ADDENDUM #2

Rye City School District

Osborn Elementary School

Midland Elementary School

1 PHASE 3 - Addition Paint Plan
SCALE: 1/4" = 1'-0"

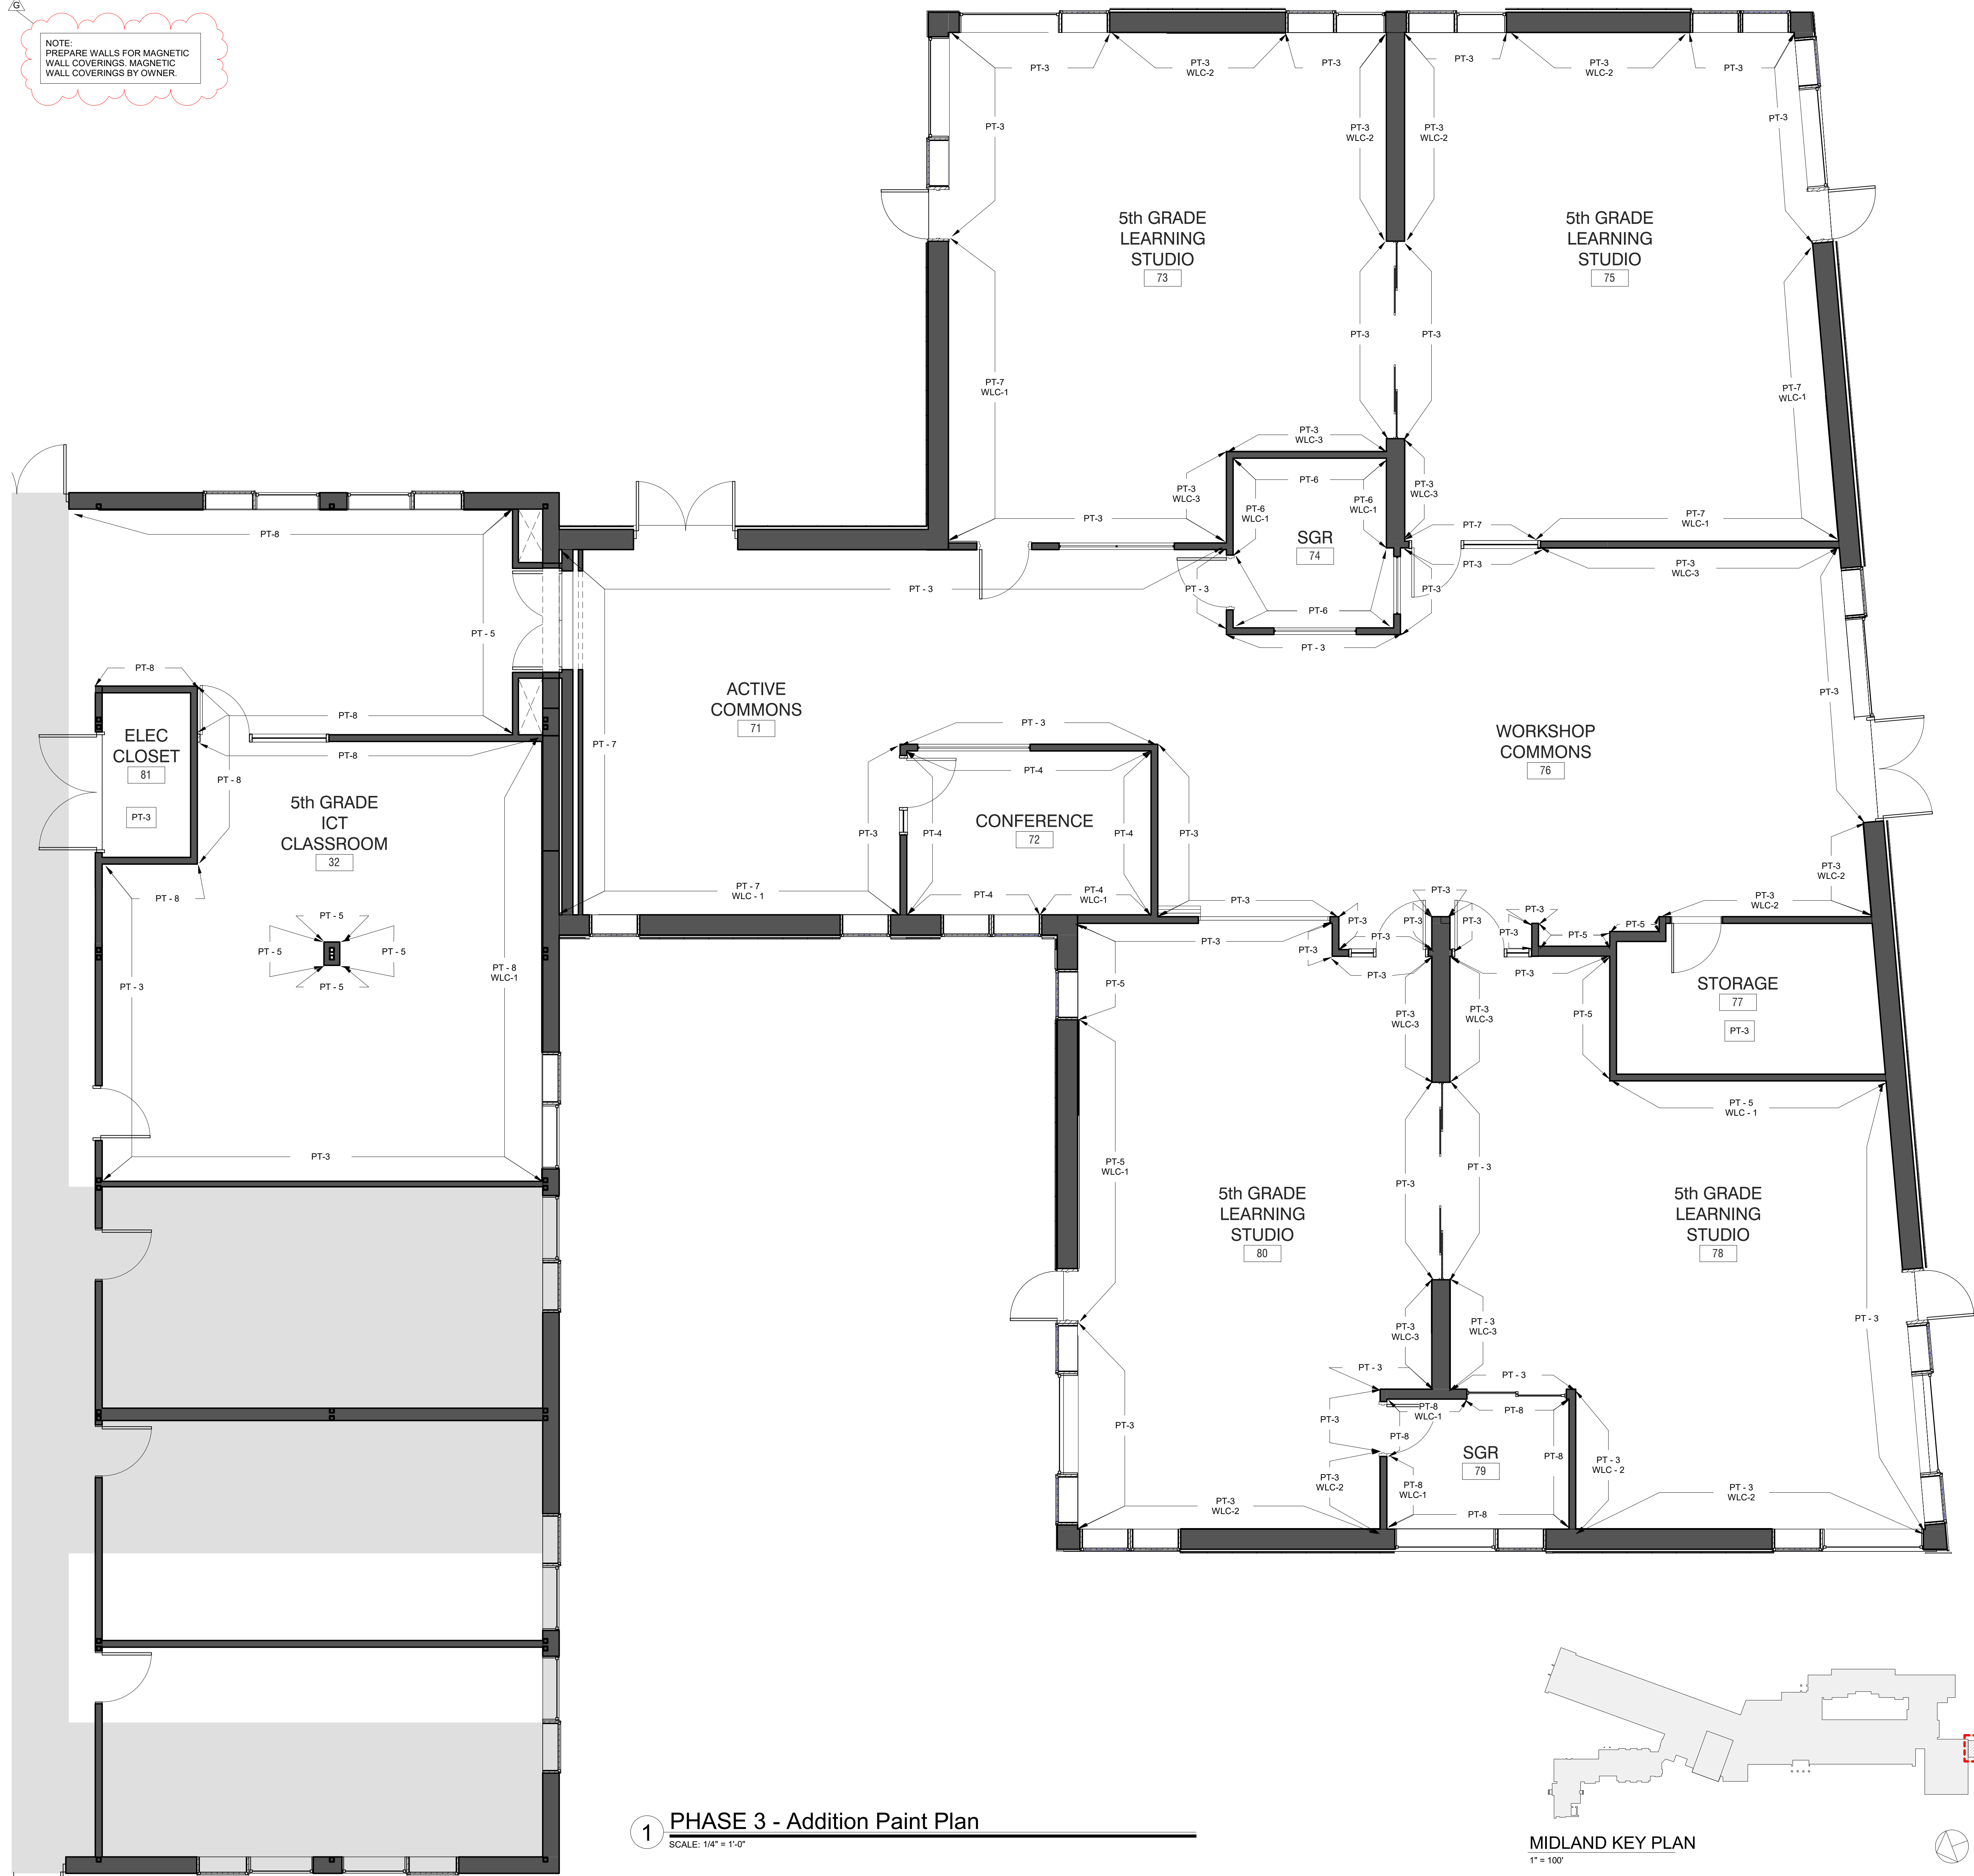
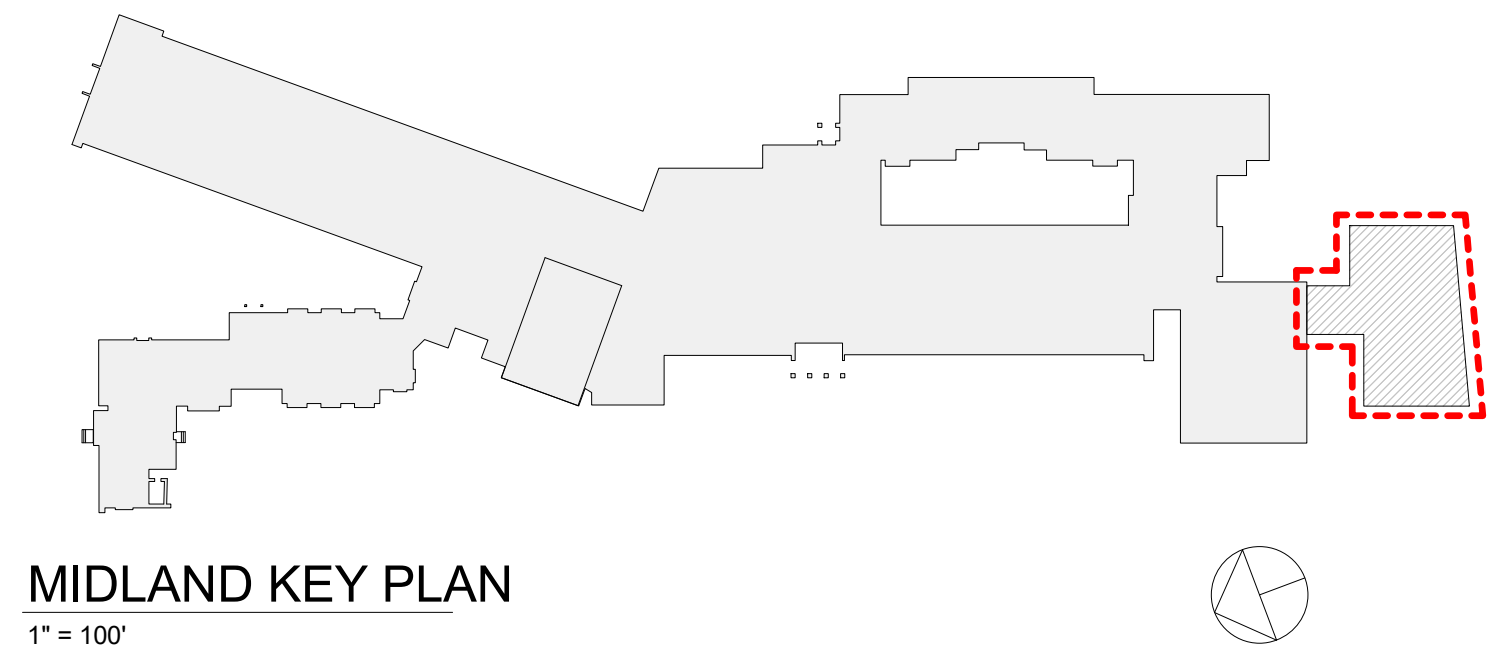
1. CIP-01, CIP-02, and CIP-03:
 - a. Drawings numbers updated to match above.
2. A3-120
 - a. Added section callouts for new details
 - b. Wall type between learning studios updated to type 3D
3. A3-210, A3-211, A3-700, A3-721
 - a. Magnetic Wallcovering to be by owner; GC to prepare walls for wallcovering by others.

NOTE:
PREPARE WALLS FOR MAGNETIC
WALL COVERINGS. MAGNETIC
WALL COVERINGS BY OWNER.

WORK NOTES:

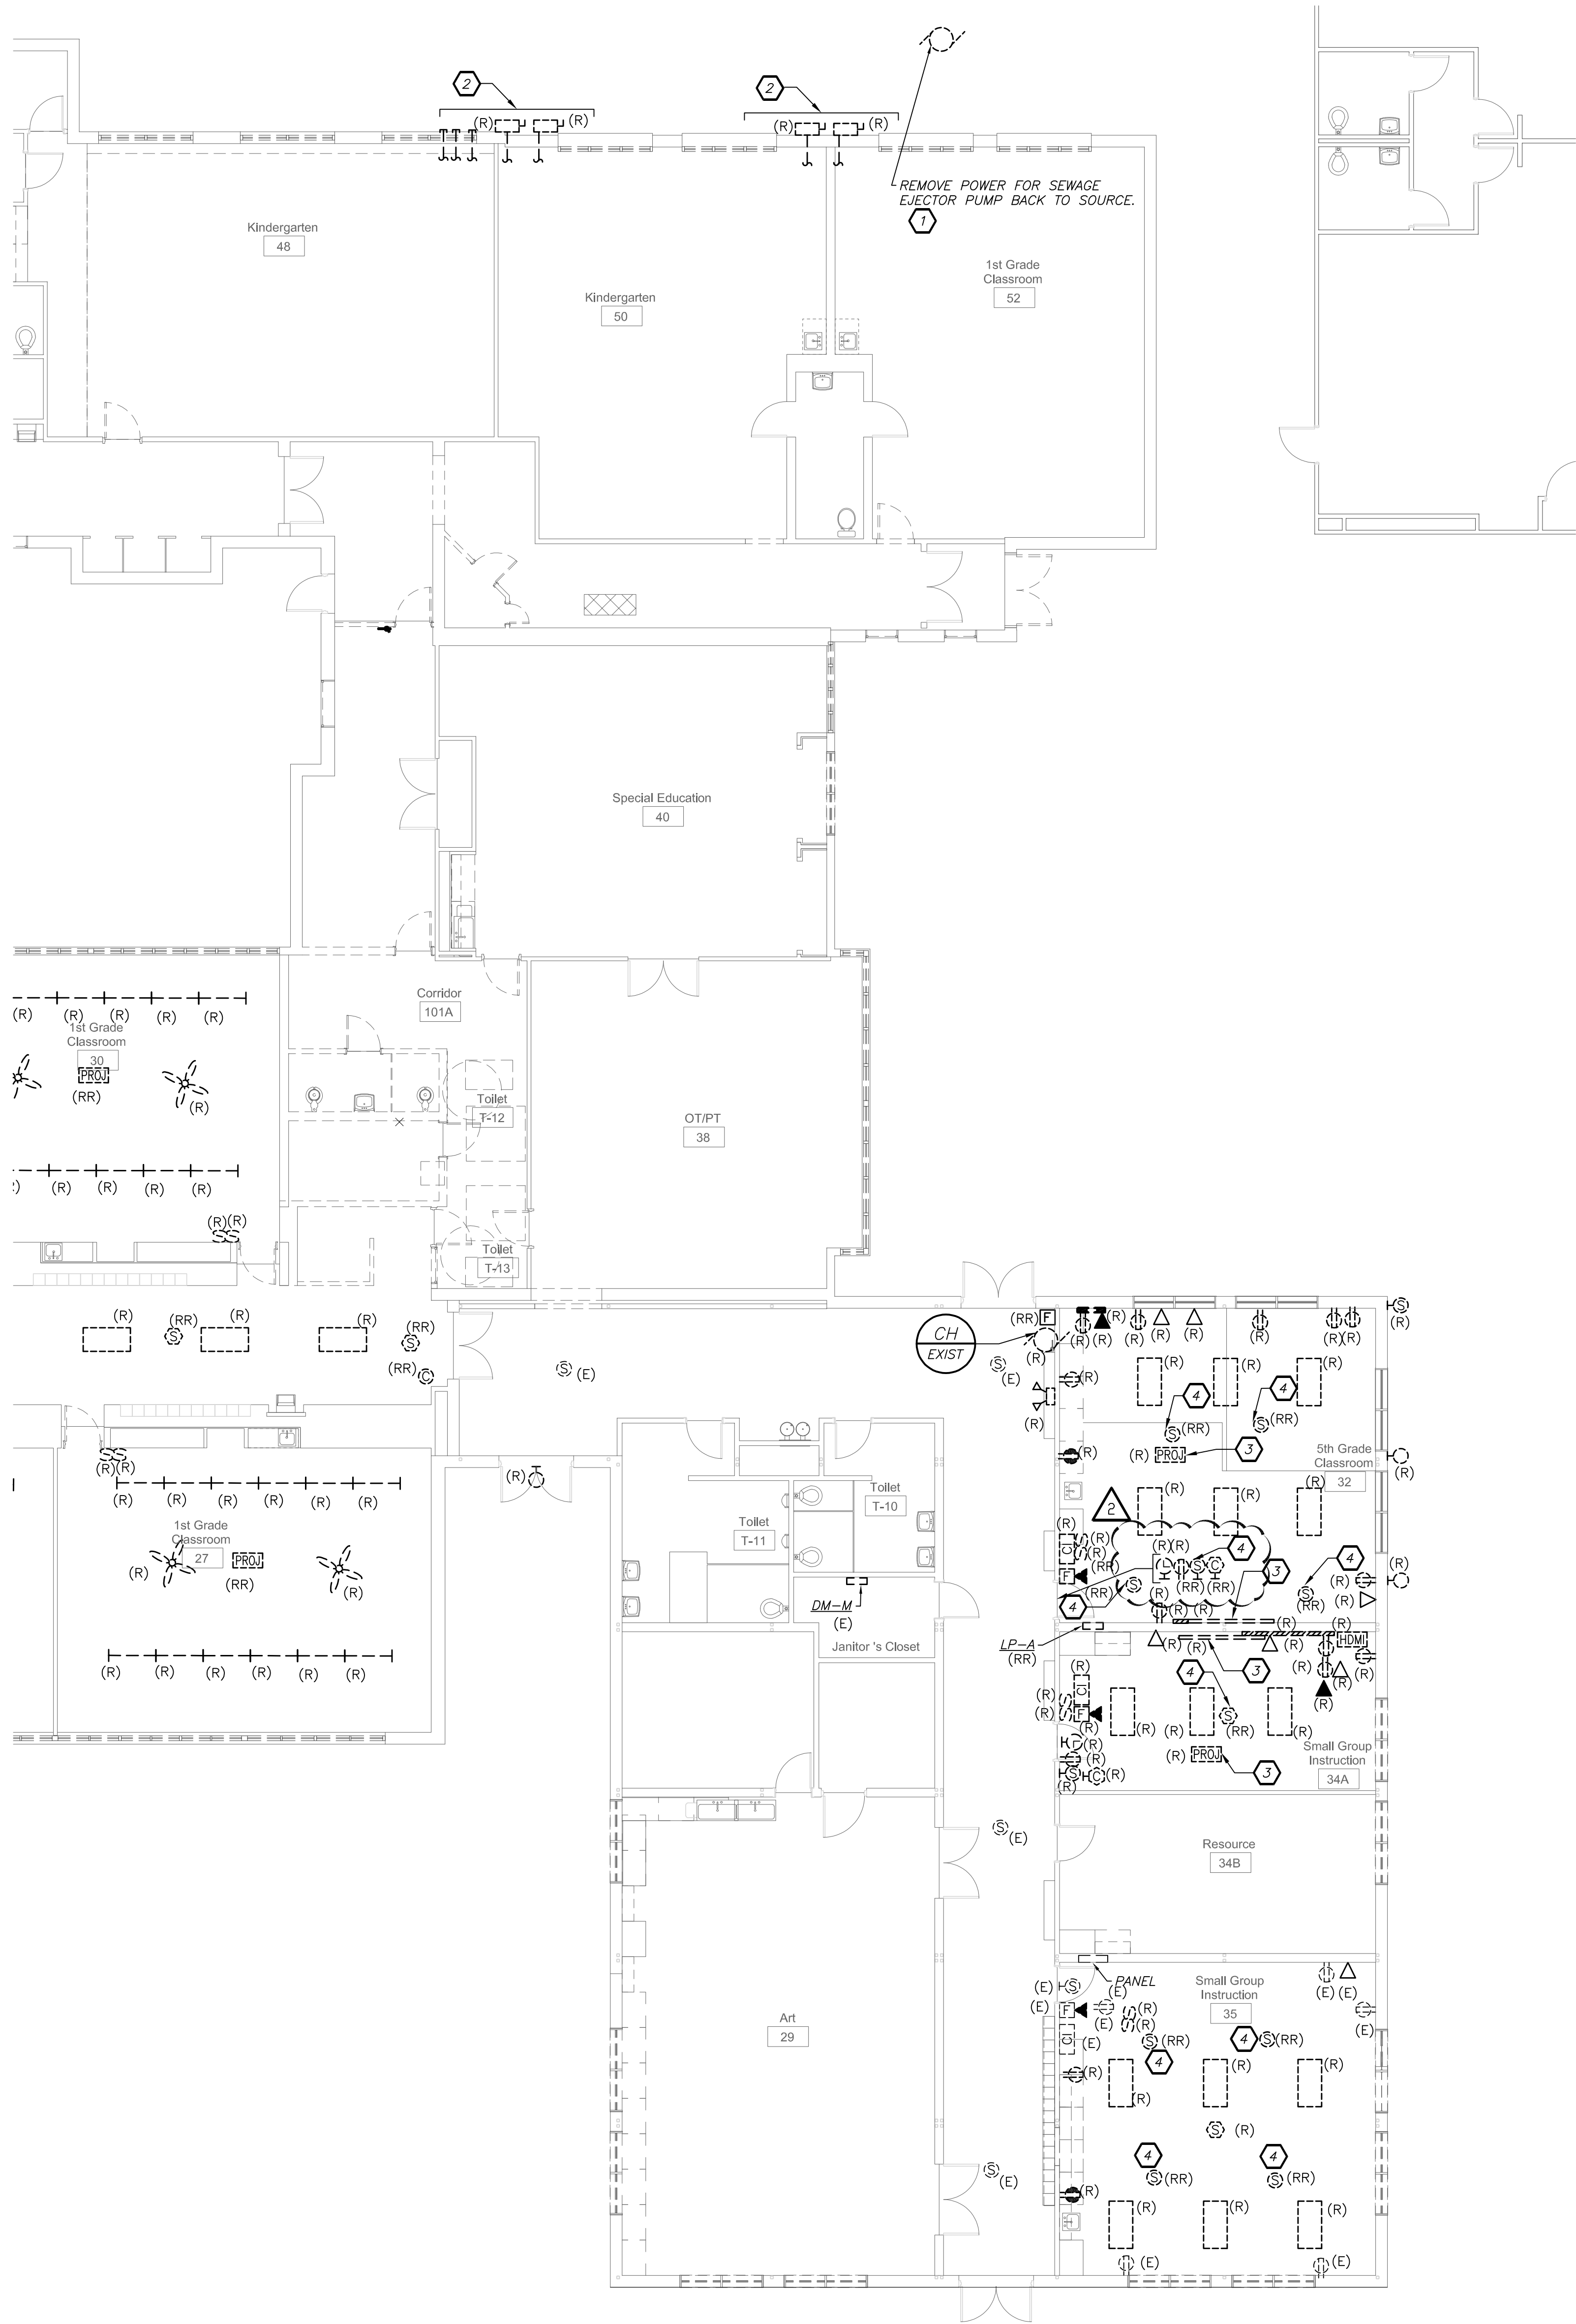
10. Refer to Revised drawing: E3-101 Electrical Removal Plan

- a. Revised work notes "2" to include removing power wiring back to source. Also, to remove (4) disconnects instead of (2).
- b. In Classroom 32, the carbon monoxide detector shall be removed and relocated.
